CHILDREN'S HOSPITAL
OF ORANGE COUNTY

TOWER II

LEVEL 1
REFLECTED
CEILING PLAN
AREA - F

A4.1F

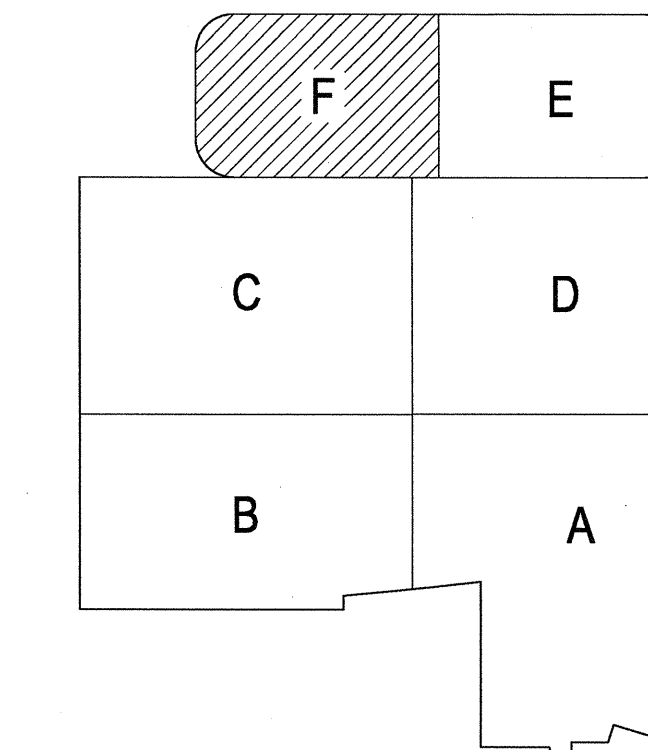
RFI 4100
See framing detail
for ceiling

RFI 4981-1 Eng.
Judgment & Rated Spill
drops for tunnel condition

RFI 4981 Rated tunnel construction
required at expansion joint. Demo of (E)
GFRP is not acceptable.

RFI #5468

RFI 4845
Install rated
expansion joint
cover in corridor for
slab edge above
